SERVICE BULLETIN No. 300-1-91

Subject: Main undercarriage U-spring
mounting clamps.
Inspection and/or replacement.

Models affected: EA-300

Sketch "A": Possible damage of the U-spring mounting clamp

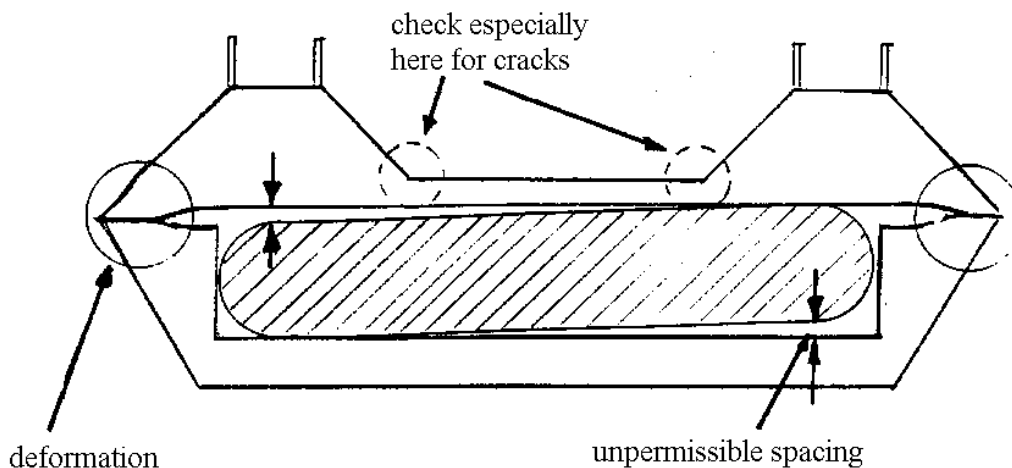
Purpose: Under certain conditions, deformations and cracks have developed in the main undercarriage U-spring mounting clamps on both sides. If cracks exist and are not corrected, the strength of the main landing gear attachment could be reduced. If deformations exist, the abrasion strips could be displaced and subsequently the glass fibre spring could be abraded. This Service Bulletin requires a repetitive inspection of the undercarriage U-spring mounting clamps to determine if cracks or deformations exist, and replacement of the main undercarriage mounting clamps with reinforced parts to eliminate the condition.

1. Remove main landing gear cuffs on both sides.
2. Inspect undercarriage U-spring mounting clamps for hairline cracks and permanently deformed areas around mounting bolts as shown on sketch "A".
3. If hairline cracks or not permissible permanently deformations are found, comply with PART II of this Service Bulletin.
4. If no hairline cracks or not permissible permanently deformations are found, replace main landing gear cuffs on both sides. Make sure of proper attachment.
5. Make appropriate logbook entry of compliance with PART I of this Service Bulletin.

3. Remove main undercarriage cuff.
4. Remove U-spring mounting clamp, including abraision strips
5. Glue new abrasion strips to new mounting clamp (top & bottom half).
6. Install new mounting clamp. Make sure to use only new self locking nuts (as provided in replacement kit) and tighten properly.
7. Reinstall cuffs.
8. Make appropriate logbook entry of compliance with PART II of this Service Bulletin.
